BLM SCALAR FIX -Based on findbhudda's original design:
<http://www.midibox.org/dokuwiki/doku.php?id=findbuddha>

Corrected blm-scalar v1.1.brd below & attached: [blm-scalar_v1.1.zip](#)

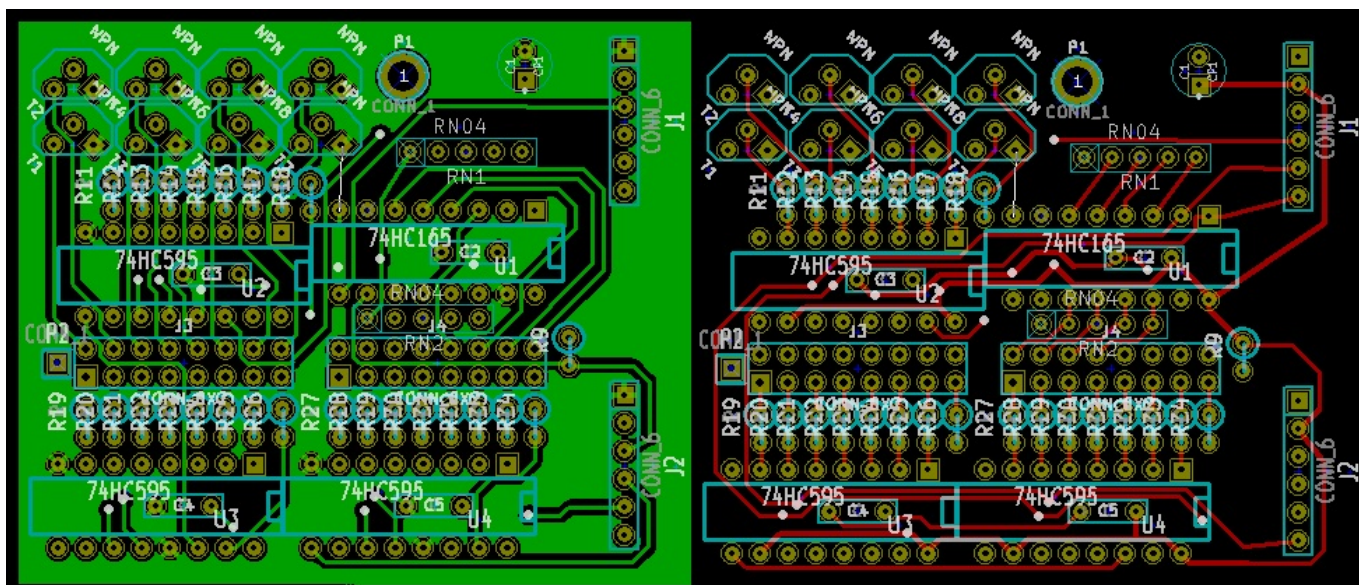
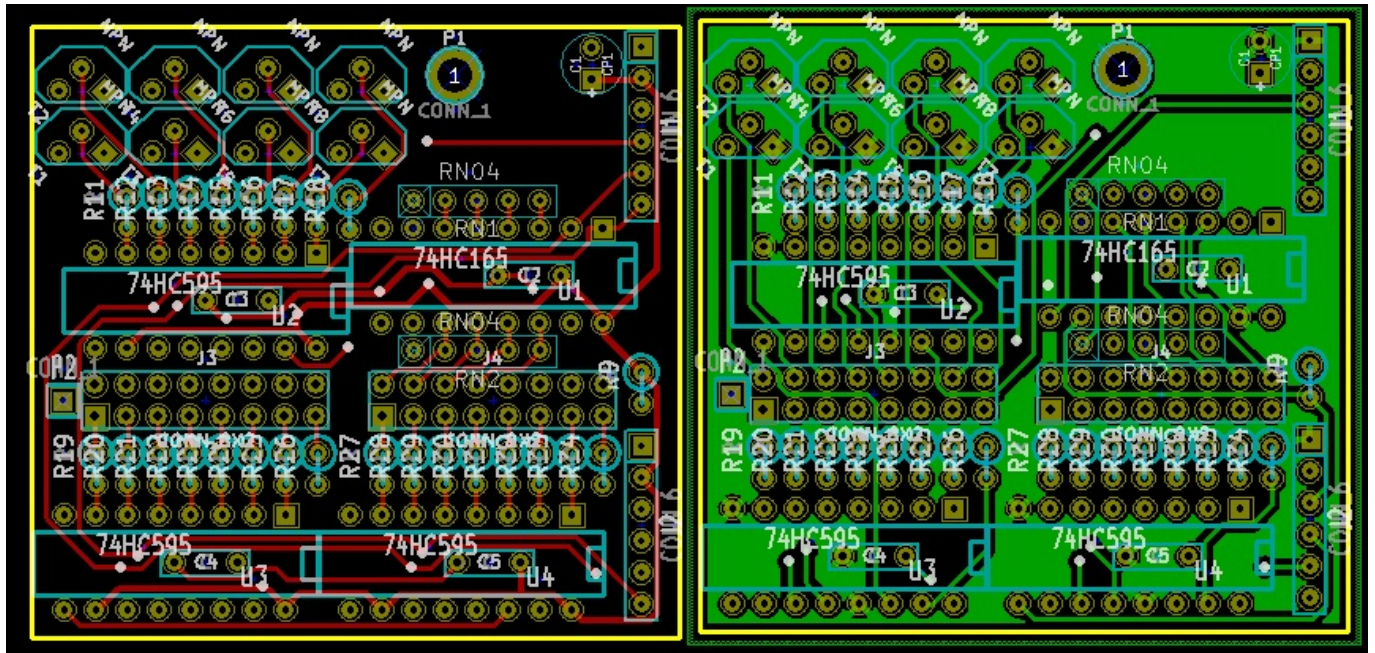
- blm-scalar.* contain an error. Pins I4-I7 are mirrored. This is easily fixed with a connector modification, and the blm-scalar module seems to work as intended.
- blm-scalar v1.1 attempts to fix this error. Moved connectors J1, J2 & Resistor Net 1 to make room for corrections.
